Access Compliance Report

Public Rights-of-Way

(Curb Ramps)

Intersection ID: N/A	Main Street: S_BREVARD_ST	Cross Street: E_STONEWALL_ST	Location: W
ADA ID: 96B73A7E08F1	Ramp Type: Directional1	Initial Pass/Fail: Pass	Overall Compliance: No
Severity Score: 0.25			
Codes/Mitigation Info/Possible Solution		Field Measurements/Component Compliance

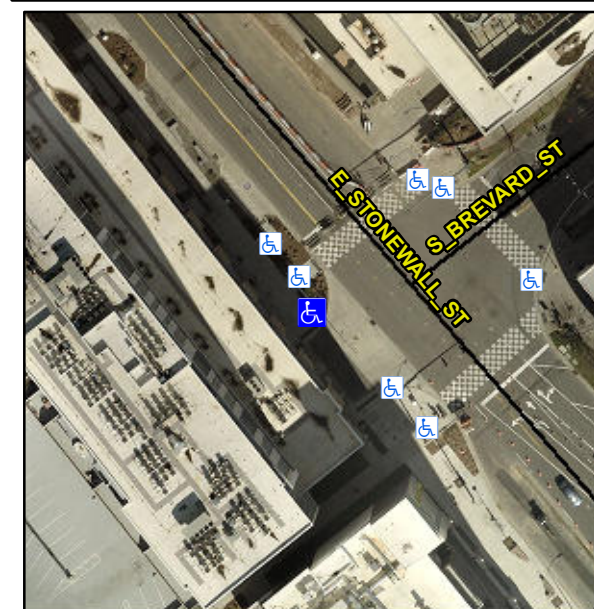
R304.5.3, R304.2.2-Perp, R304.3.2-Para

Compliance	Description	Data	Compliance	Description	Data
N/A	Ramp Length (in)	78.0	Yes	Grade Break?	Yes
Yes	Ramp Width (in)	60.0	Yes	Grade Break Slope (%)	0.5
Yes	Ramp Slope (%)	0.8	Yes	Grade Break XSlope (%)	0.1
No	Ramp XSlope (%)	2.2			
N/A	Flare Type LT	N/A	N/A	Flare Type RT	N/A
N/A	Flare Slope LT (%)	N/A	N/A	Flare Slope RT (%)	N/A
N/A	Flare Traversable LT?	N/A	N/A	Flare Traversable RT?	N/A
Yes	Landing Length (in)	48.0	Yes	DWS Provided?	Yes
Yes	Landing Width (in)	48.0	Yes	DWS Contrast?	Yes
No	Landing Slope (%)	2.3	Yes	DWS Length (in)	24.0
Yes	Landing X Slope (%)	1.0	Yes	DWS Full Width?	Yes
N/A	Landing Curb? (Y/N)	N/A	Yes	DWS Offset LT (in)	40.0
N/A	Shared Landing?	No	Yes	DWS Offset RT (in)	1.0
Yes	Gutter Ponding?	No	Yes	Gutter Slope (%)	0.9
Yes	Gutter Lip Ht (in)	0.0	Yes	Gutter X Slope (%)	0.1
N/A	Painted X Walk1?	Yes		Road Slope (%)	1.0
	X Walk 1 Direction	To SE		Road X Slope (%)	0.4
	X Walk 1 Width (in)	144.0		Clear Space?	Yes

X Walk 1 Slope (%)	1.0	N/A	Clear Space to XWalk (in)	N/A
	X Walk 1 X Slope (%)	0.4	Yes	Storm Grate/Utility Hazard?	No
Yes	Ramp inside XWalk1?	Yes		Storm Grate/Utility Type	
Yes	Any Obstructions?	No			N/A
	Obstruction Type		Yes	Surface Condition? (G/P)	Good
			N/A	Curb Slope (%)	1.3

Remove & Replace Entire Ramp.
